DOCUMENT 00 90 00 ADDENDUM

ADDENDUM No.: 4

RE: LA CROSSE HOUSING AUTHORITY

2024 CAPITAL IMPROVEMENT PROJECTS

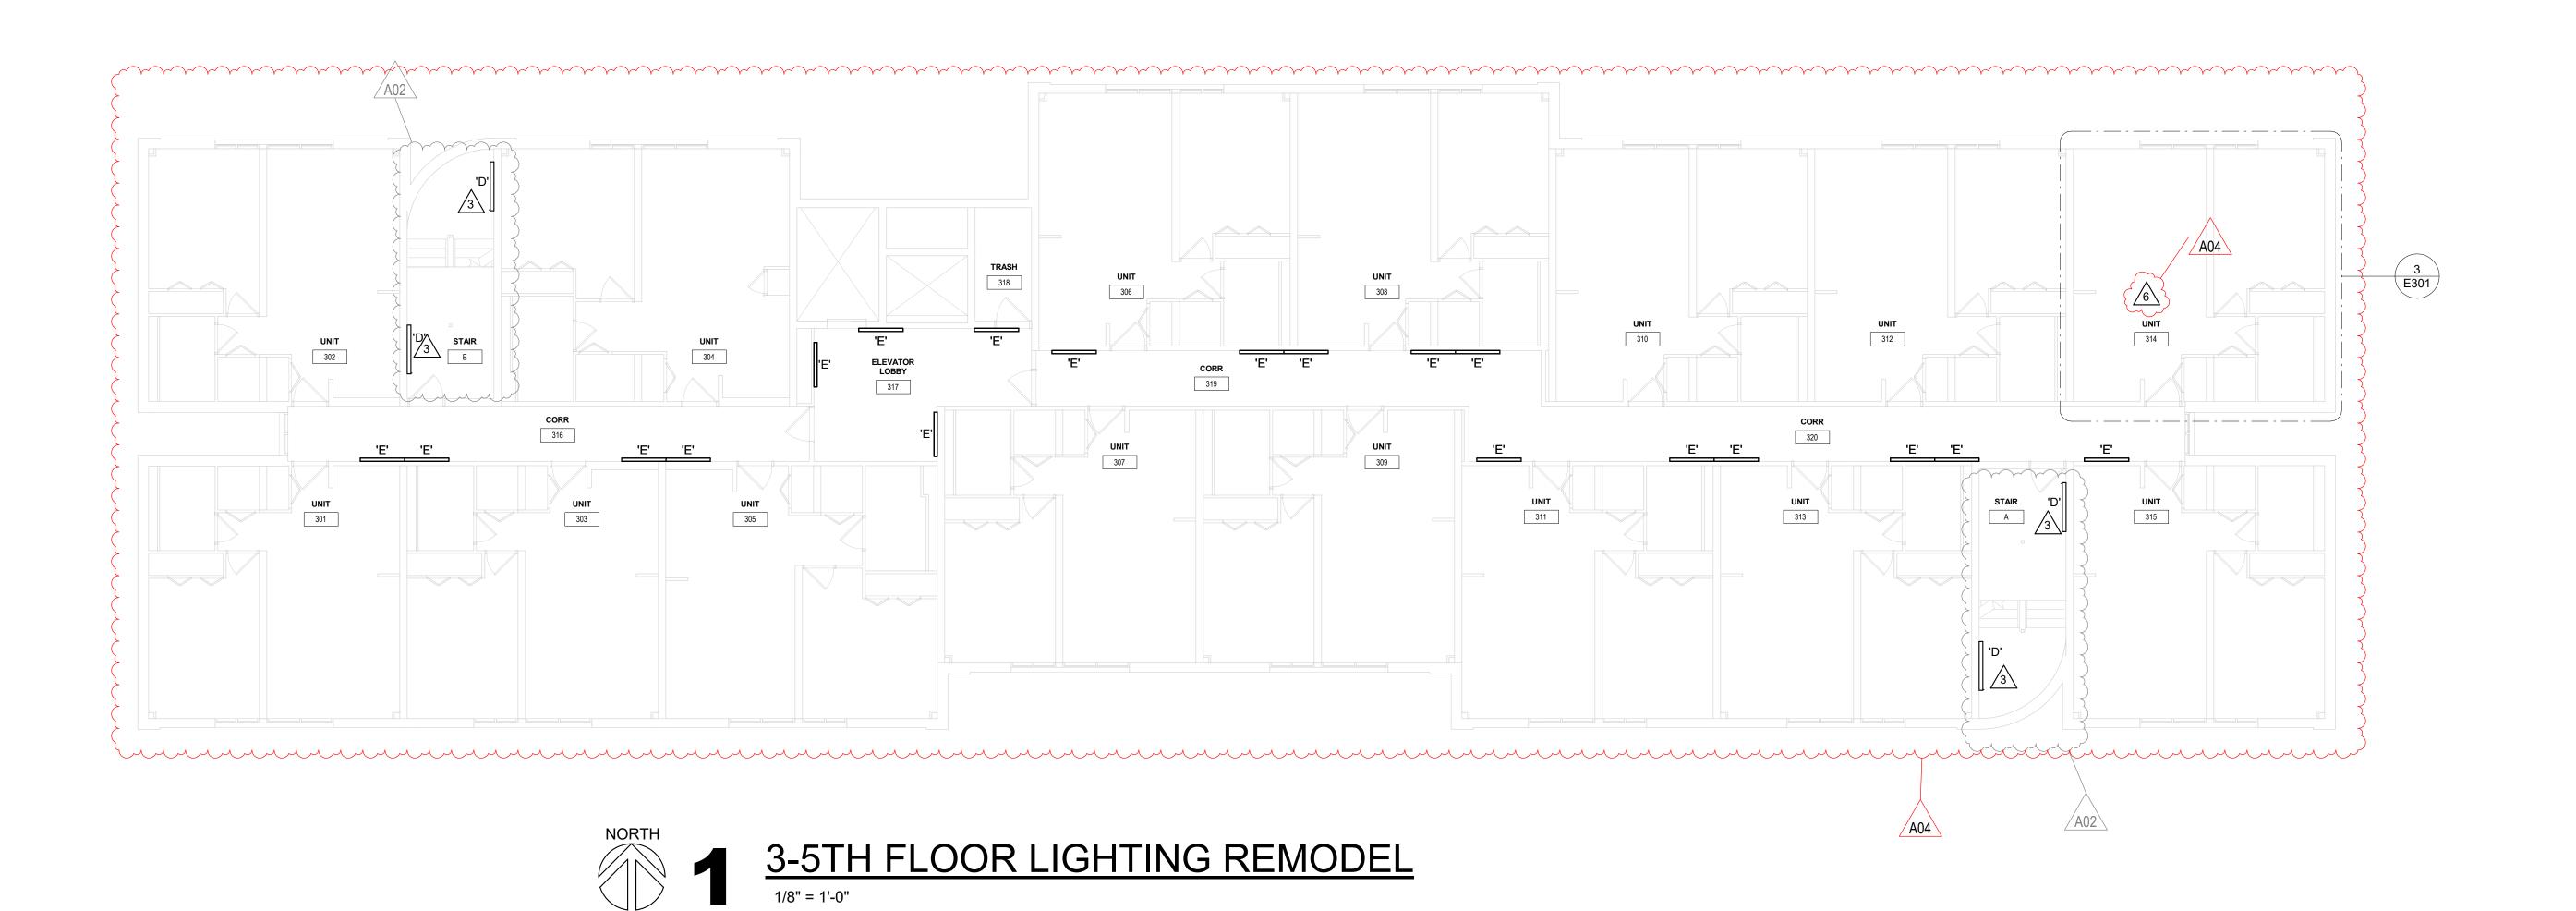
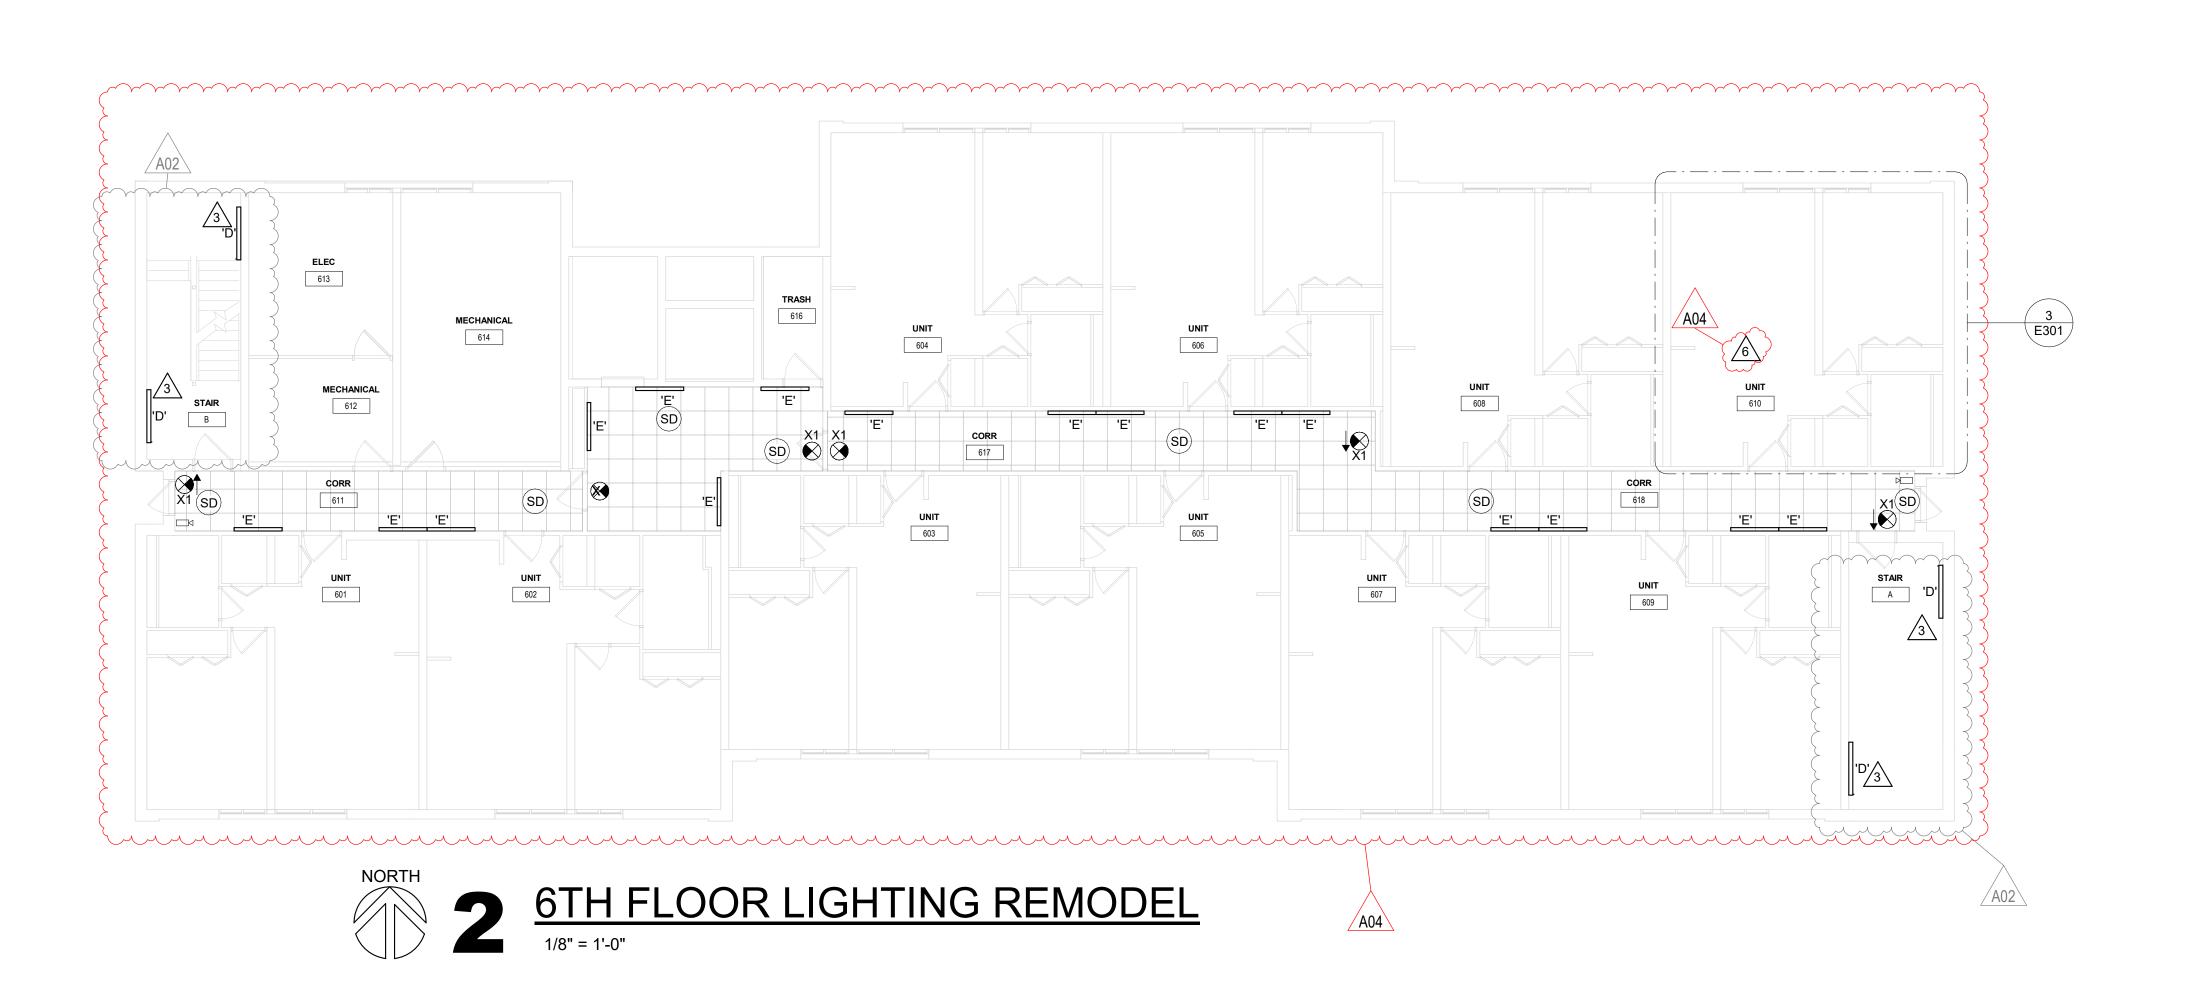
- a. See the revised sheet included in this addendum. Disregard the previous version.
- b. Clarified fixture name/model/description in schedules.
- c. Added room names and numbers.
- d. Added Key Note 6 regarding removal and installation of lights in all 1 bedroom units in the building.
